LAKE PONTCHARTRAIN, LOUISIANA AND VICINITY
LAKE PONTCHARTRAIN BARRIER PLAN
DESIGN MEMORANDUM NO. 2 - GENERAL
SUPPLEMENT NO. 4

NEW ORLEANS EAST
BACK LEVEE

March 1971

LMVED-TD (NOD 18 Mar 71) 1st Ind
SUBJECT: Lake Pontchartrain, Louisiana and Vicinity, Lake Pontchartrain
Barrier Plan, General Design Memorandum No. 2, Supplement No. 4,
New Orleans East Back Levee

**NEW ORLEANS EAST BACK LEVEL
 PLAN AND PROFILE
 STA. 664+73.3 TO STA. 774+00**

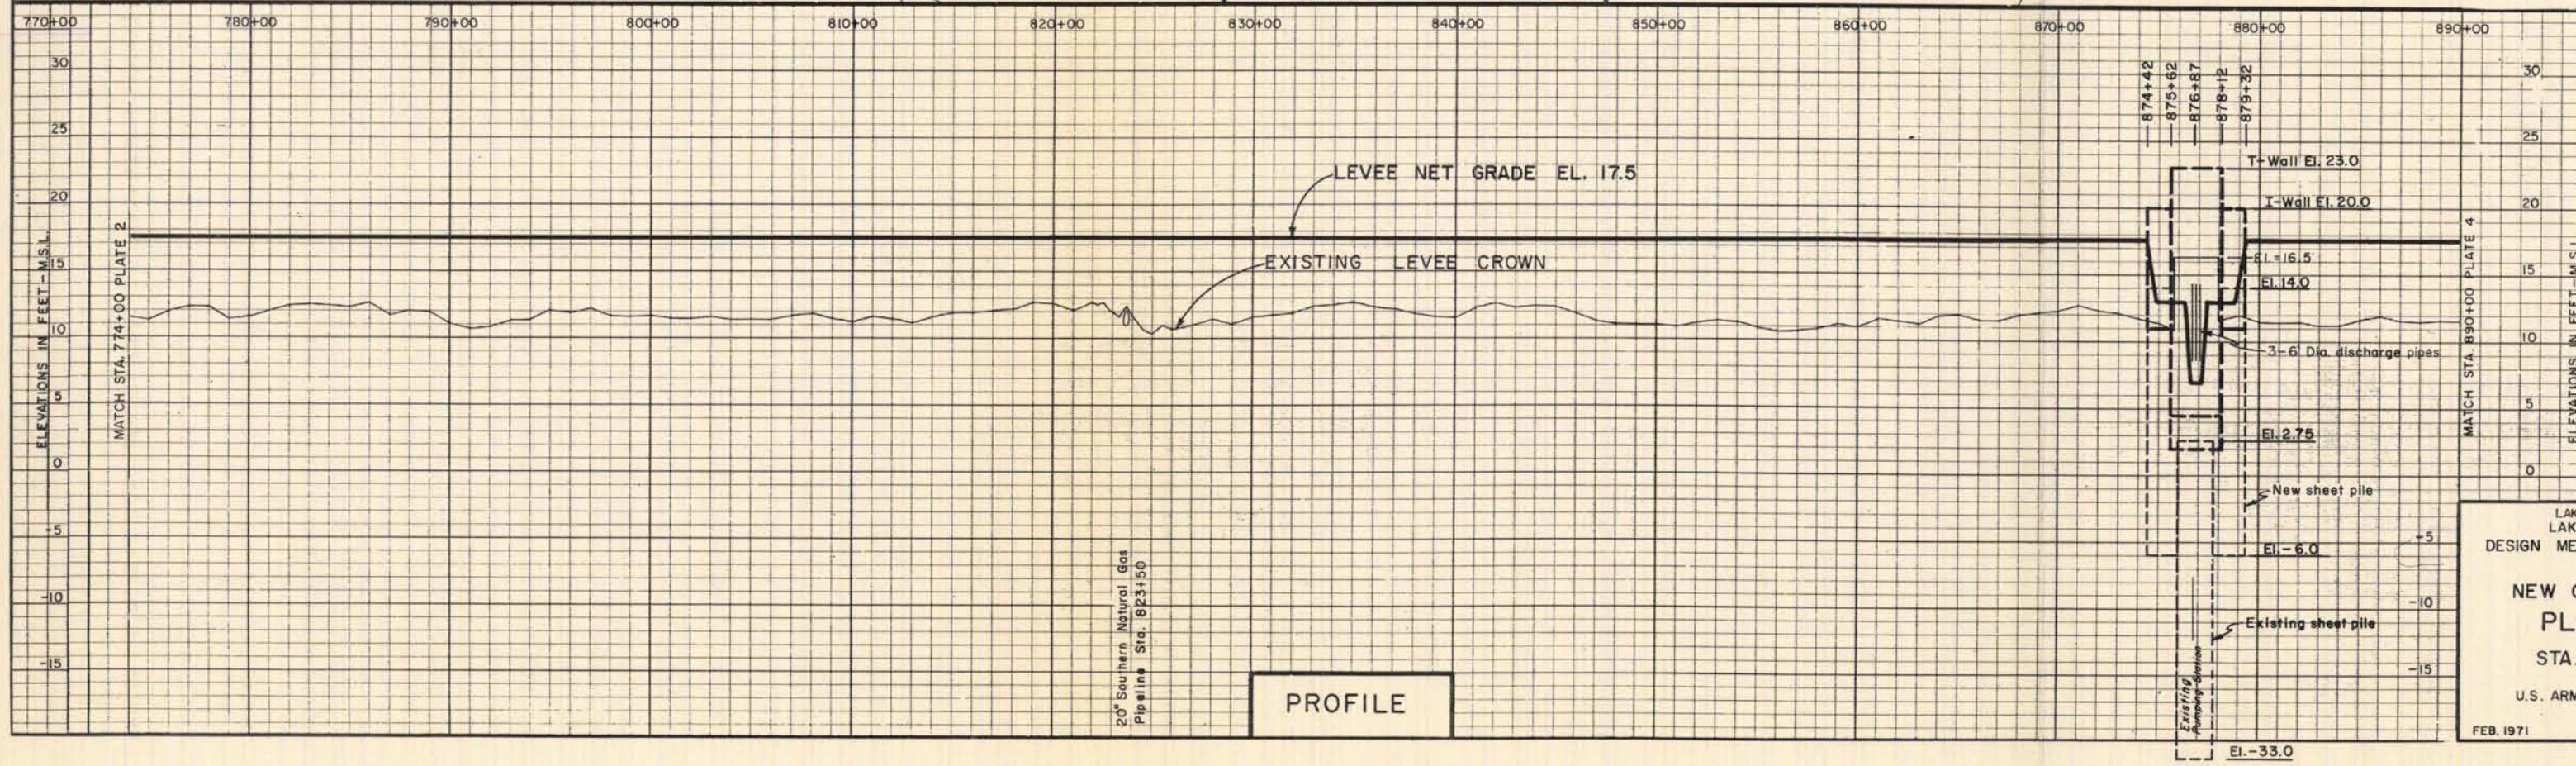
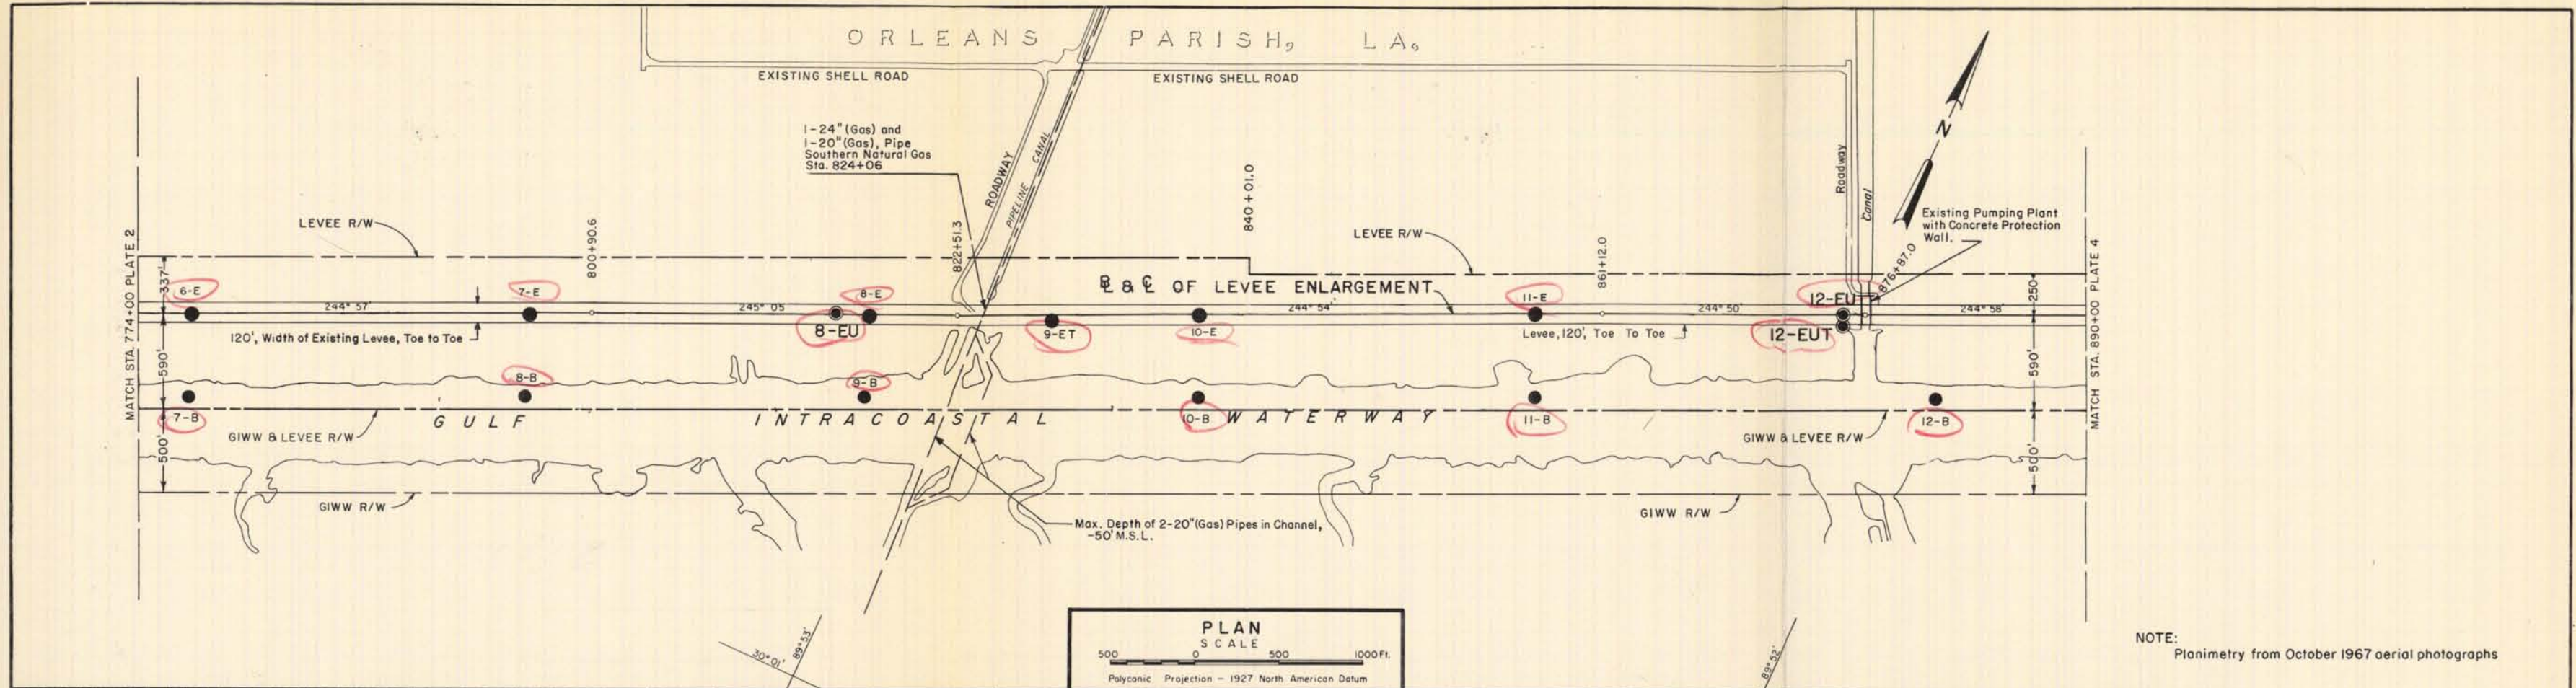
- b. The baseline stations of 711+77.5, 718+34.2, and 765+75.0 for the pipeline crossings on page 30 do not agree with those on plan and profile plate 2. These discrepancies should be reconciled.

11. Para 71c, page 30. The stationing of Louisiana Cement Company conveyor system is given as 716+56.2 in this paragraph as 716+53.25 on plate 2 and as 716+55.25 on plate 74. These stations should be corrected during preparation of plans and specifications.

13. Plate 2. The electrical cables shown on the profile at approximate station 738+64 should be shown on the plan.
14. Plate 3. a. The 24" Southern Natural Gas pipeline at station 823+50 should be shown on the profile.

i. Para 10a & 10b. The elevation of the Southern Natural Gas Co. high pressure gas line as shown on page 29 and plate 3 is in error and should read elevation -6.0. The baseline stations for the pipeline crossings as shown on plate 2 are the correct stations.

j. Para 11. The correct station for the Louisiana Cement Co. conveyor system should be station 716+55 as shown in plan on plate 2. The plans and specifications will indicate the correct station.

I-WALL & LEVEE CONFIGURATION
 STA. 664+73.3 TO STA. 772+00

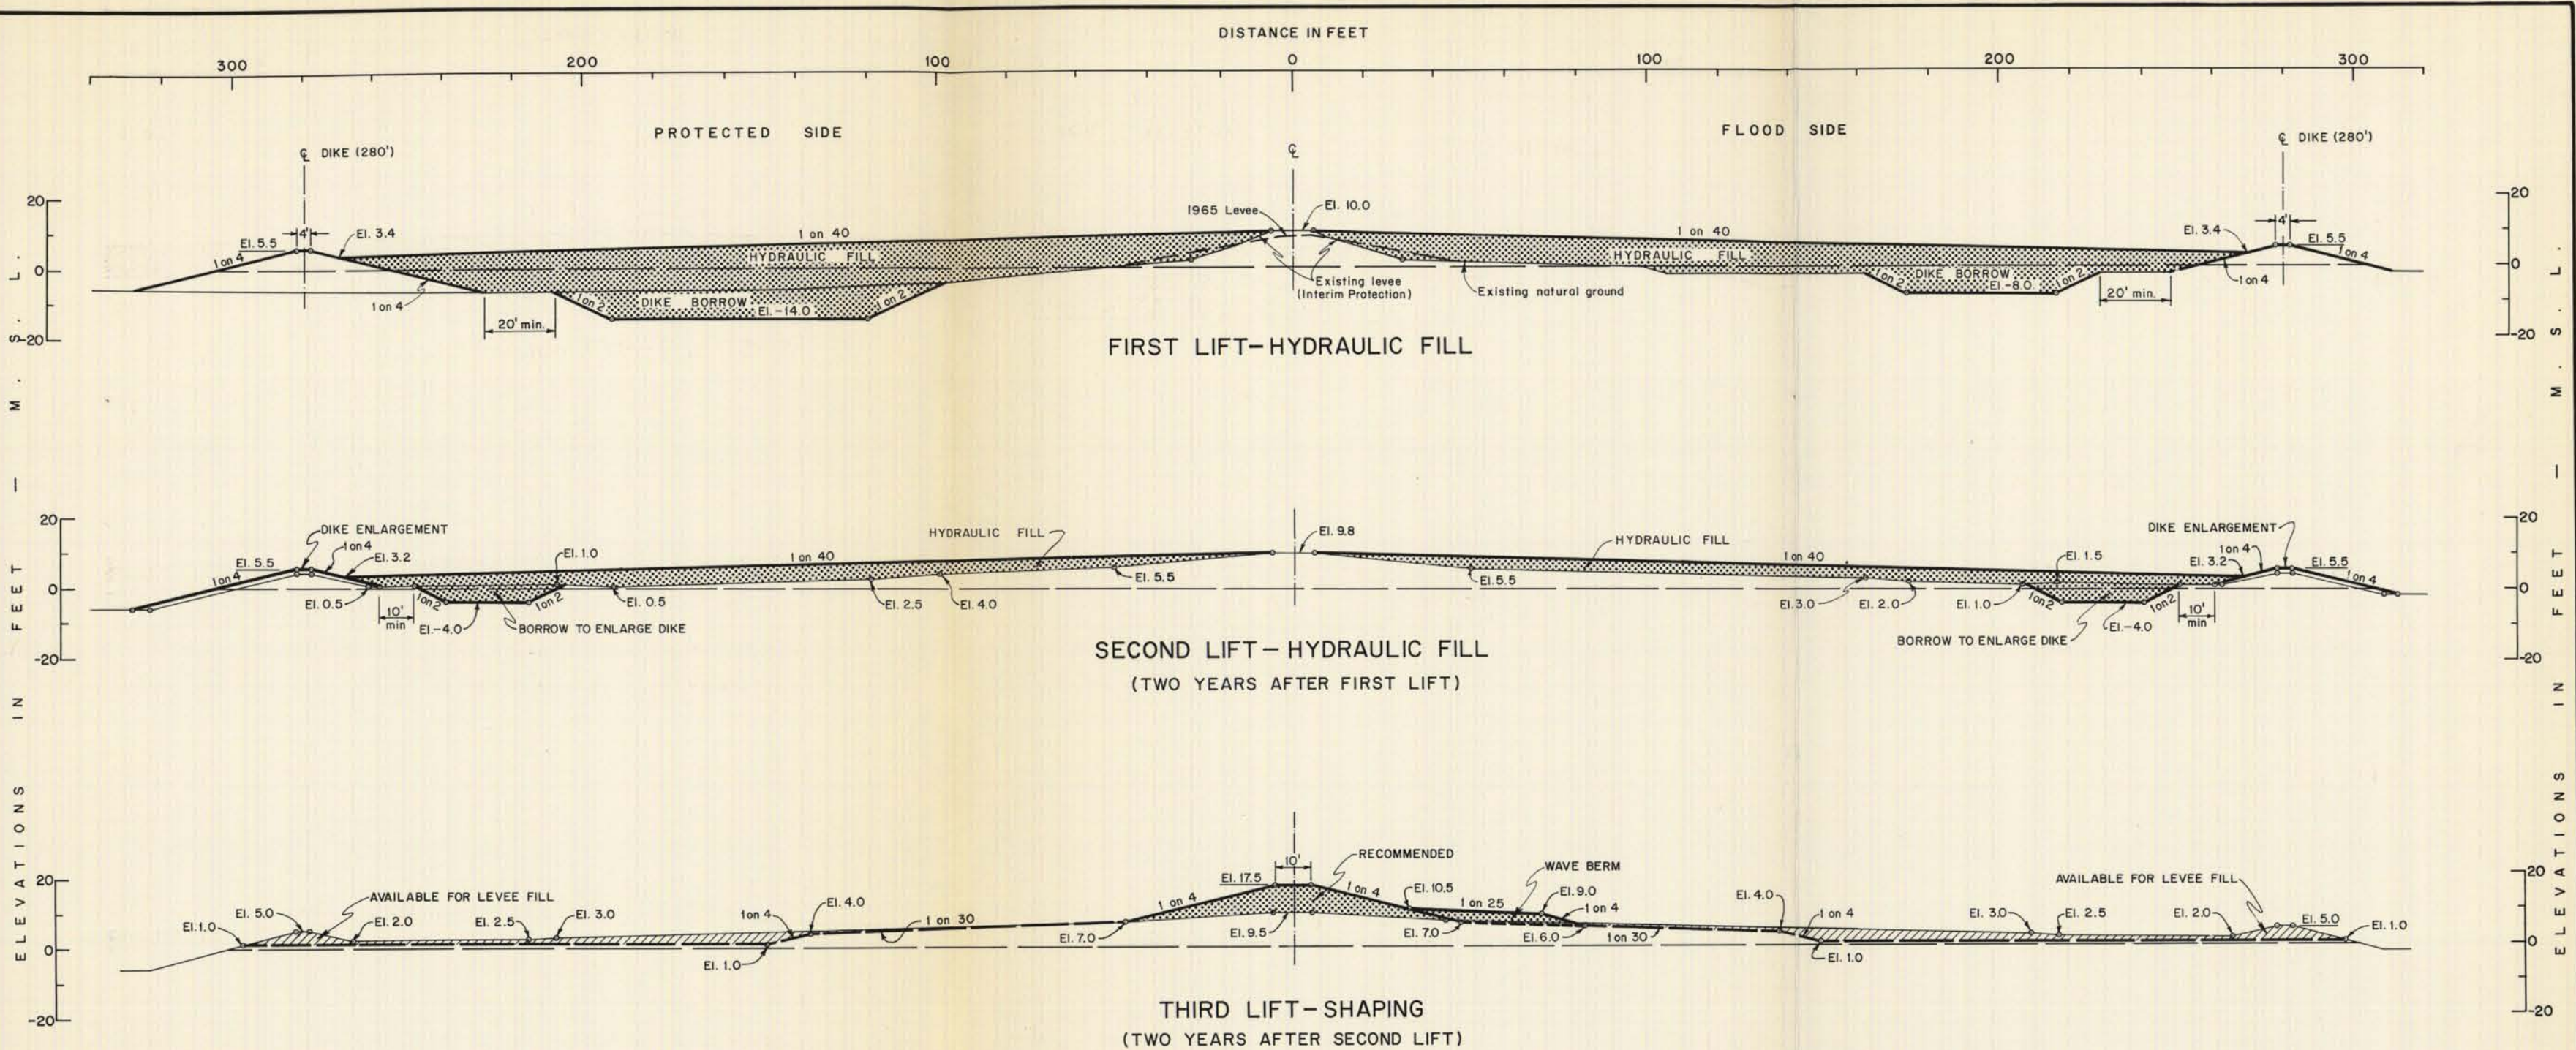
2. Table of Contents, page vi. Title for Plate 29 should read "I-wall and levee configuration (Sta 664+73.3 to Sta 772+00)."
3. Para 33 b(1), page 13. Plate 61 referred to in this sentence is the stability analysis of an I-wall levee, not an earthen levee. This reference should be corrected.
